Boston Alternative Energy Facility

Worst Case Assessment for Land Raising

Document Reference: 9.77

Subject: Boston Alternative Energy Facility: Deadline 7 - Worst Case Assessment for Land Raising

TITLE **BOSTON ALTERNATIVE ENERGY FACILITY DEVELOPMENT CONSENT ORDER Regulation 5(2)(o) - Technical Note - Deadline 7 Worst Case Assessment for Land Raising Figure 1**

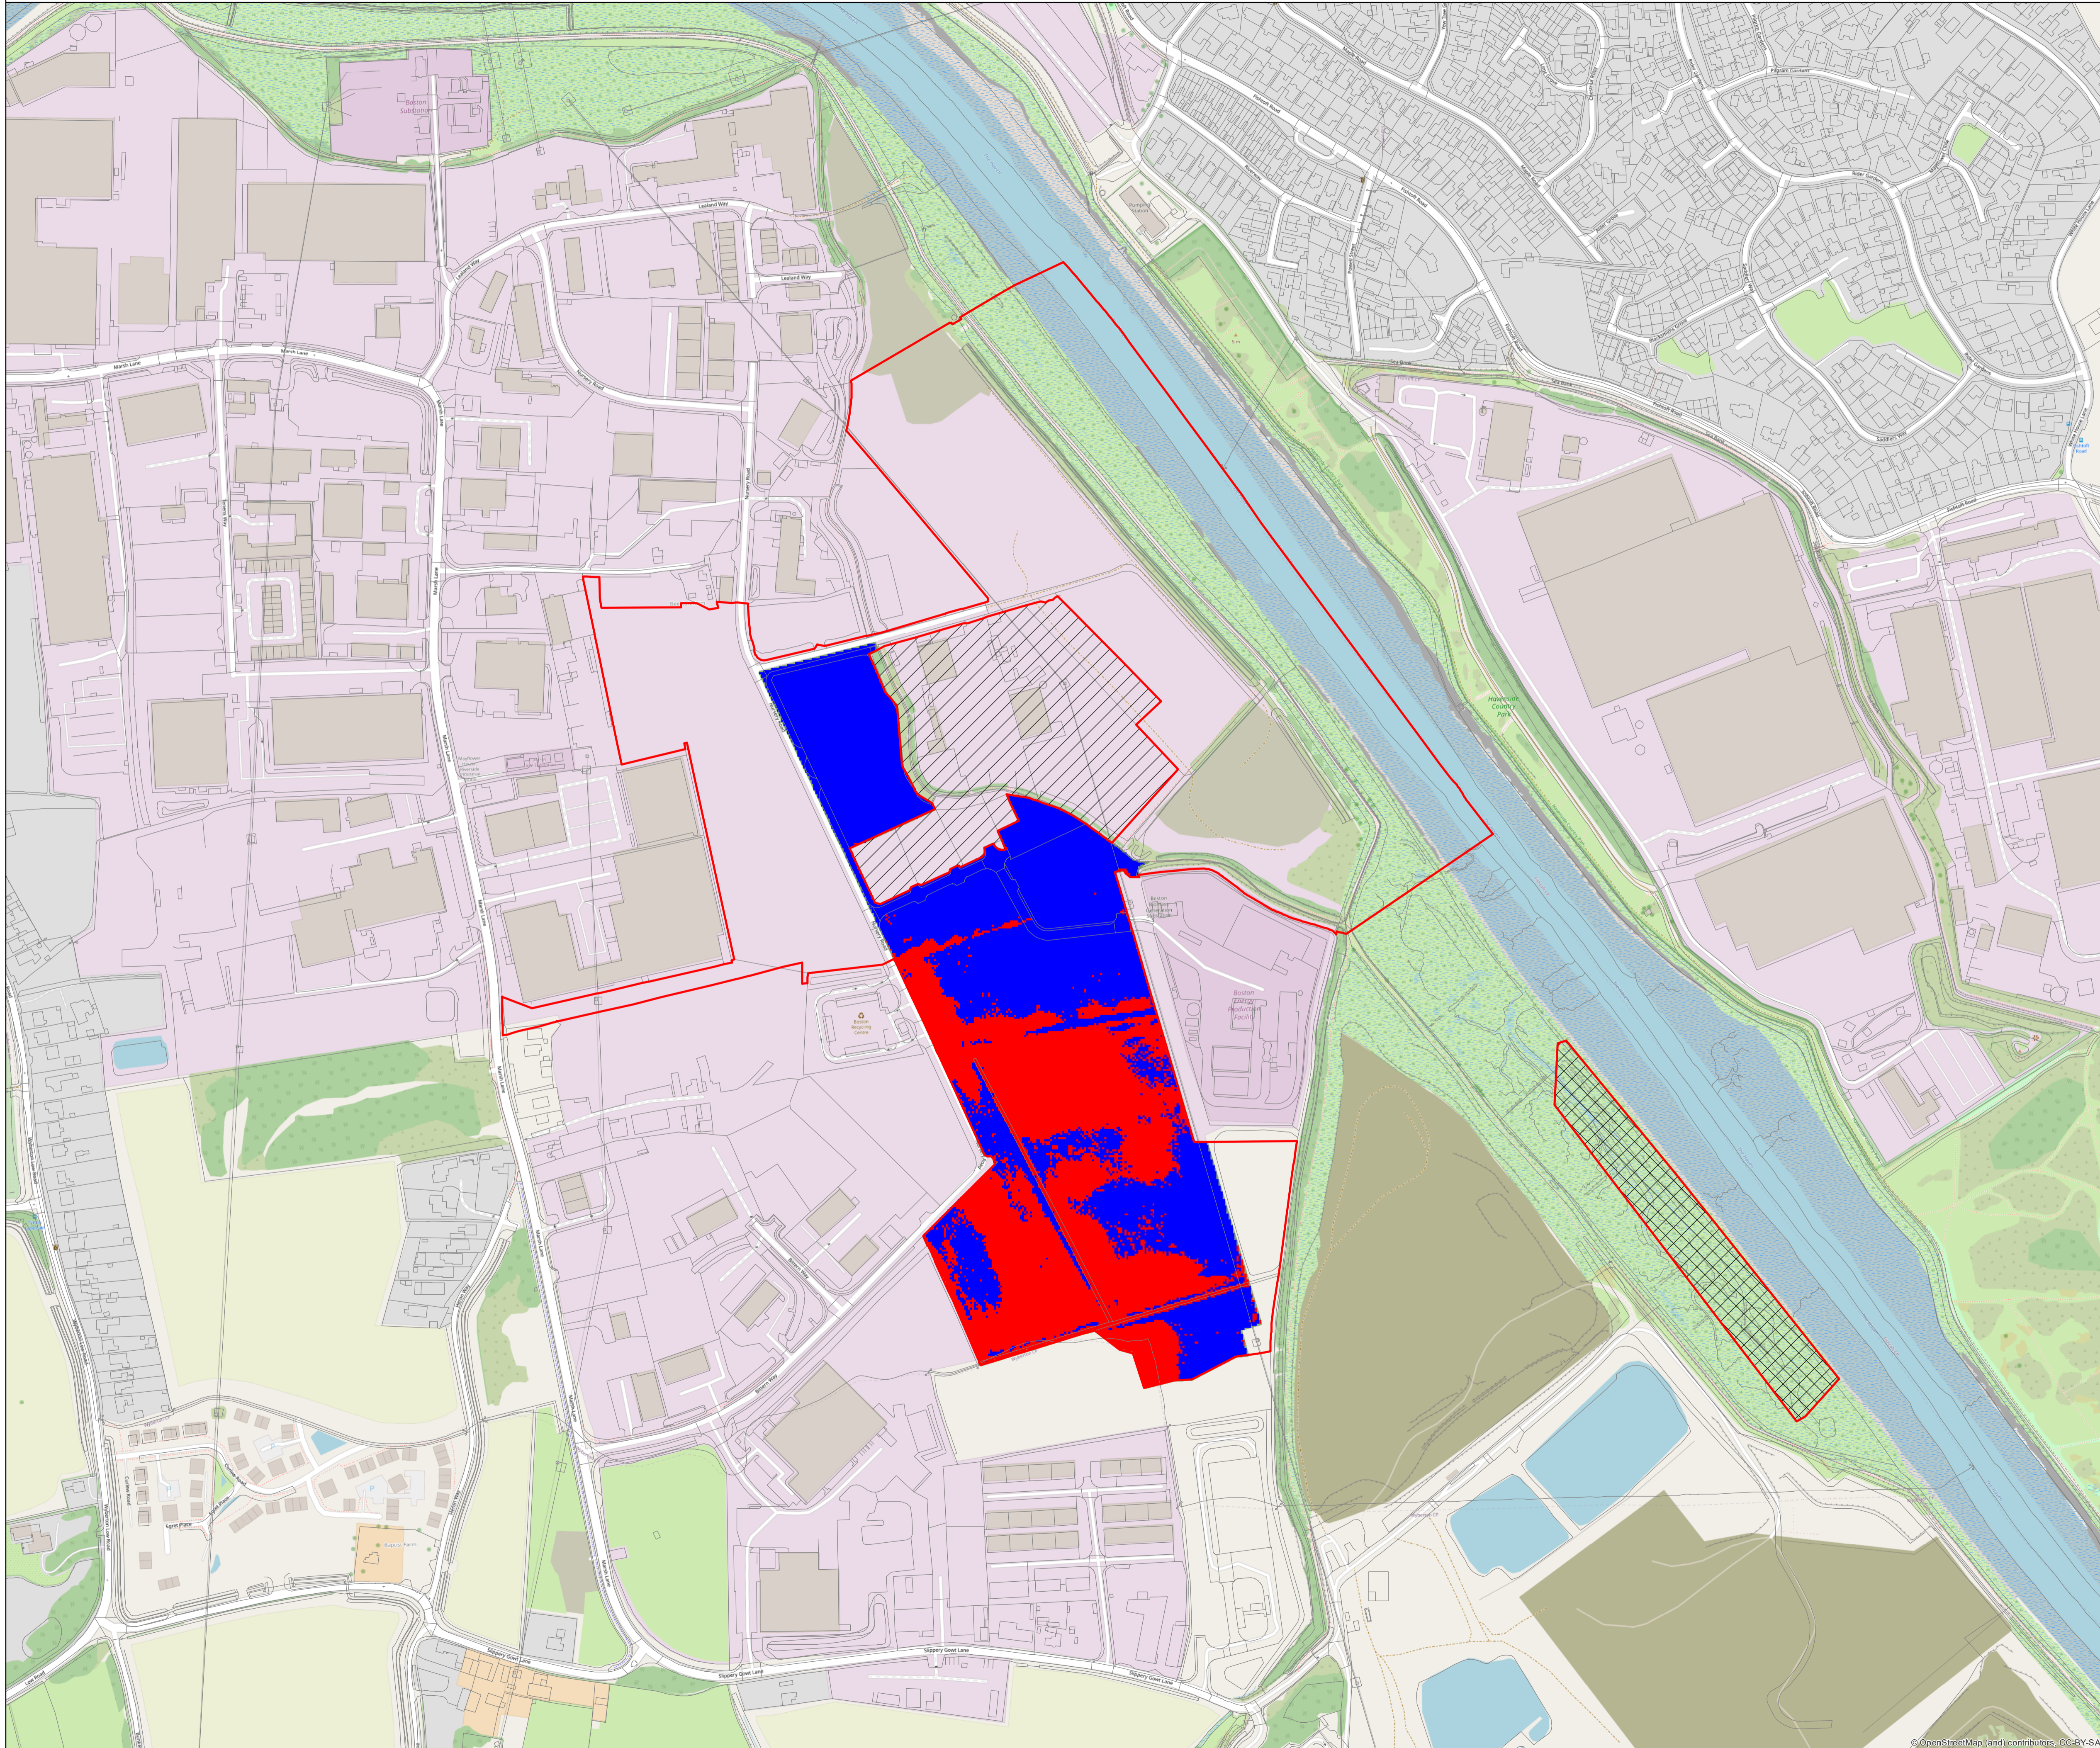
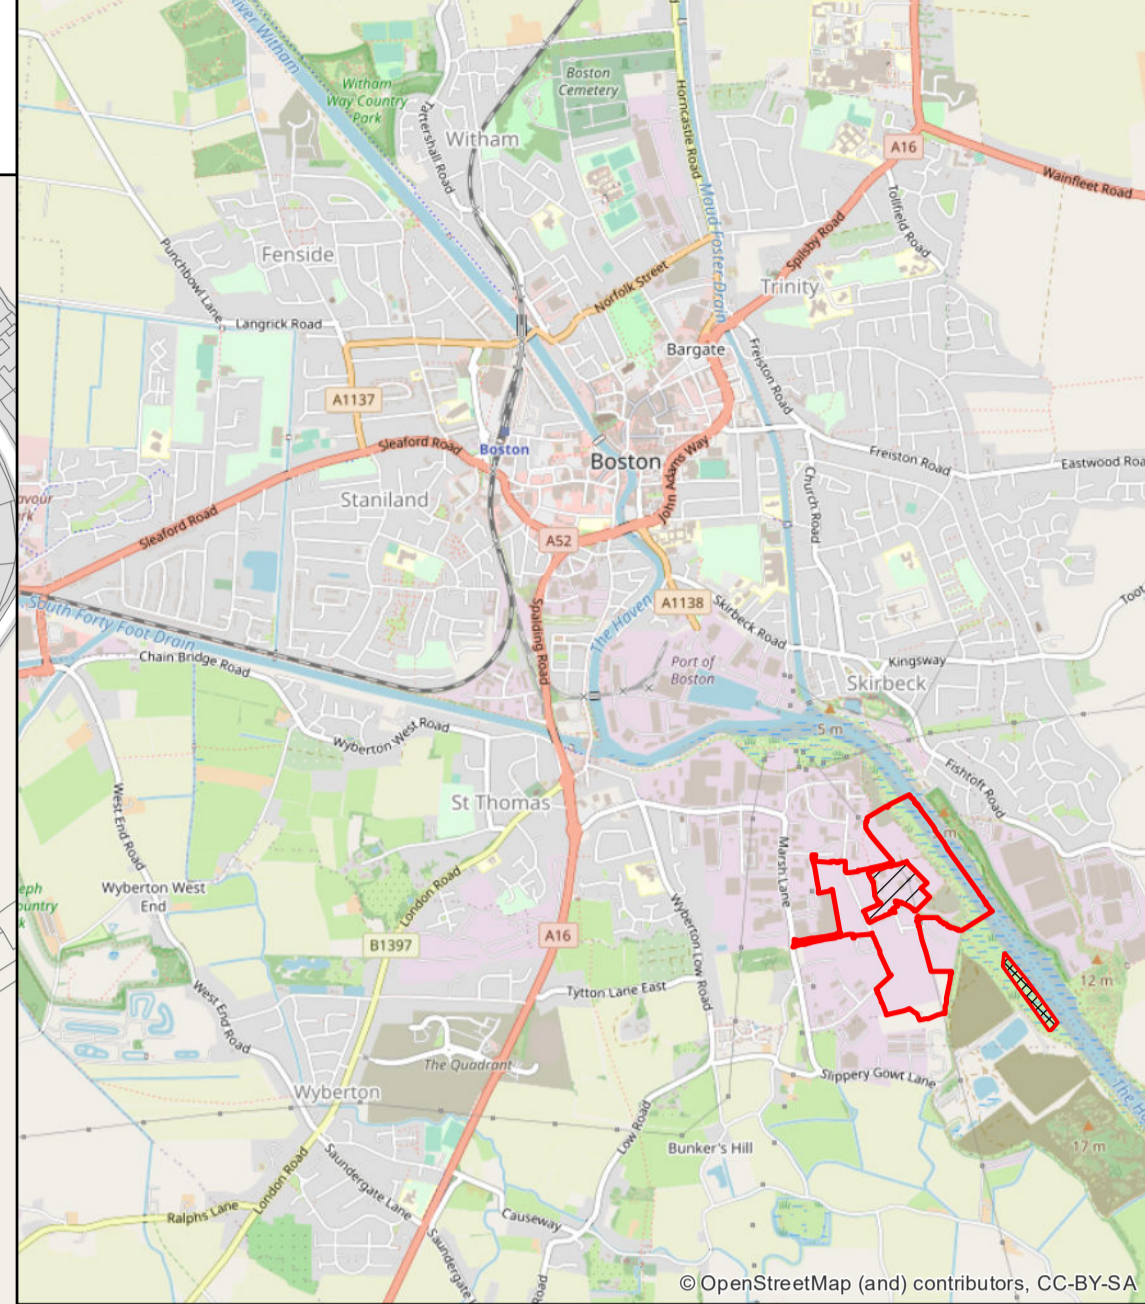
“Paragraph 3.3 We require details of finished site levels including assessment of any impact on the flow of water over the site. The Applicant has indicated to us that approximately 0.5 m of surface material will be removed and replaced with 0.8 m of surcharged material across the main site. This gives a net gain of 0.3m over the whole site. We require further assessment of the impact on flood risk to third parties through the displacement of flood waters.”

- 4.1.2 As can be seen in **Figure 1**, the land subject to levelling is focused on the Principal Application Site. The land proposed for the construction car parks and laydown areas, to the west and north west of Nursery Road will not be subject to ground levelling. Therefore, these areas have been excluded from the assessment.

- 4.1.3 As would be expected for an undeveloped site currently comprising mainly agricultural land, there are localised variations in the topography and gradients across the Site. As noted previously, the greater elevations are towards the northern end of the Site and lower elevations towards the southern end of the Site. **Figure 1** shows where this will result in minor lowering of ground levels compared with the locations where this will result in minor raising of ground levels.

- 5.1.3 Following calculation of the areas of the Site that will require lowering of ground levels (i.e. cut) compared with those areas that will require raising (i.e. fill), as summarised in **Table 1**, it is concluded that generally the existing ground levels across the Site are sufficiently elevated that there will be limited permanent raising of ground levels across the Site, following construction.

- 5.1.6 However, on the basis that the additional volume of potential flood storage, associated with ground lowering, would be in excess of the loss of potential flood storage associated with ground raising it has been concluded that there will be no increased displacement of flood water, should there be a breach in the defences in the future.
